Great Ormond Street Hospital
 Phase 2 B

Drawing Title
 SOUTH ELEVATION
 2105 update

Drawing Number: 00_2B_E_S
 Revision: C14

South Elevation

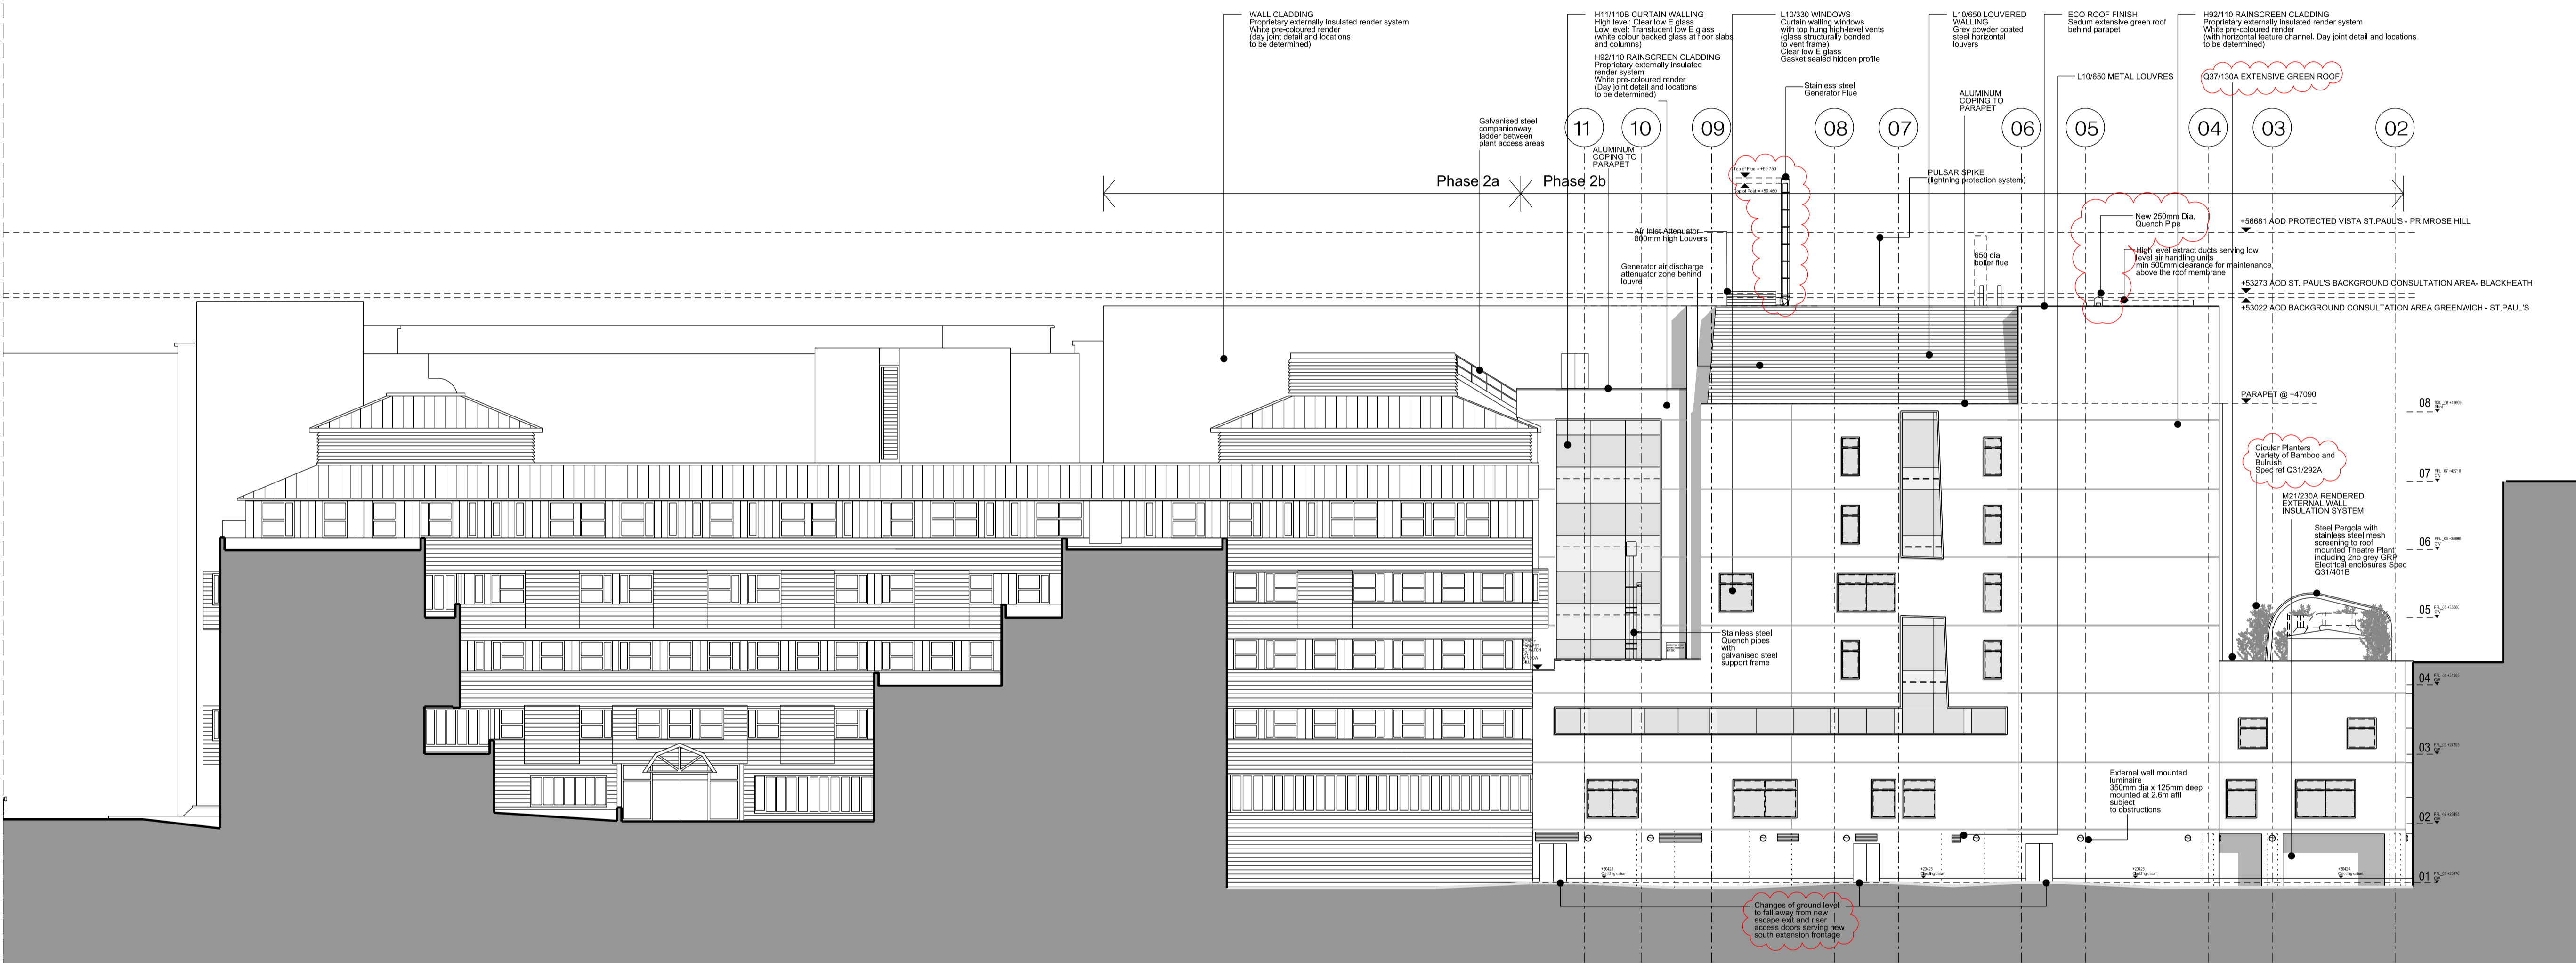
The following changes are listed below
 -horizontal feature channels continued between grids 02 & 04
 -notes added
